**Support Document for the
Revised National Priorities List
Final Rule
SBA Shipyard
September 2016**

**Site Assessment and Remedy Decisions Branch
Office of Superfund Remediation and Technology Innovation
Office of Land and Emergency Management
U.S. Environmental Protection Agency
Washington, DC 20460**

This document provides responses to public comments received on the SBA Shipyard site, proposed on September 30, 2015 (80 FR 58658). This site is being added to the NPL based on an evaluation under EPA's Hazard Ranking System (HRS) in a final rule published in the *Federal Register* in September 2016.

Figure 1: Approximate Source 4, the Former LTU, location as shown on page 2 of Reference 16 of the HRS documentation record at proposal.

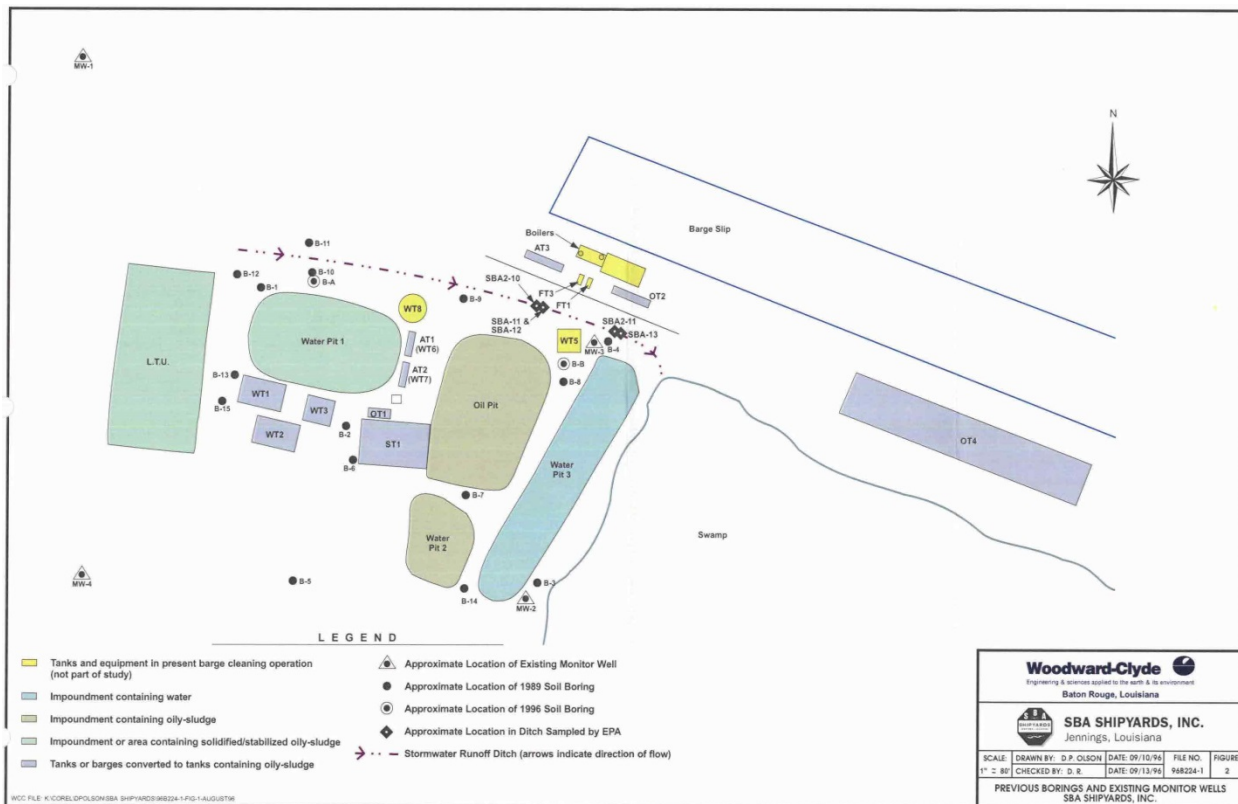
Comment: The Companies commented that Figures 2, 3, and 4 of the HRS documentation record at proposal are incorrect with respect to Source 4, asserting that there is “no factual basis for depicting the location of the landfarm.”

On page 8 of the HRS documentation record at proposal, Figure 2 of the HRS documentation record at proposal provides the approximate locations of scored sources and other components relevant to the Site. Page 5 of the HRS documentation record at proposal details the references supporting the elements of the HRS documentation record figures. It states in relevant part:

Cited Reference 16 of the HRS documentation record at proposal contains the figures for the October 1996 RCRA Facility Investigation Work Plan, prepared for SBA Shipyards, Inc. by Woodward-Clyde Consultants (included as Reference 6 of the HRS documentation record at proposal). Page 2 of Reference 16 is a figure showing the location of the Former LTU as well as other components of the facility at the time. A cropped version of that page is shown in Figure 1 below:

Cited page 10 of Reference 24 of the HRS documentation record at proposal (the 1994 Compliance Evaluation and Sampling Inspection At SBA Shipyards, Inc., Jennings, Louisiana, LAD008434185) also contains a figure showing the approximate location of the LTU. During the 1994 compliance evaluation inspection a site reconnaissance was conducted, during which SBA Shipyards owner Mr. Smailhall was present.
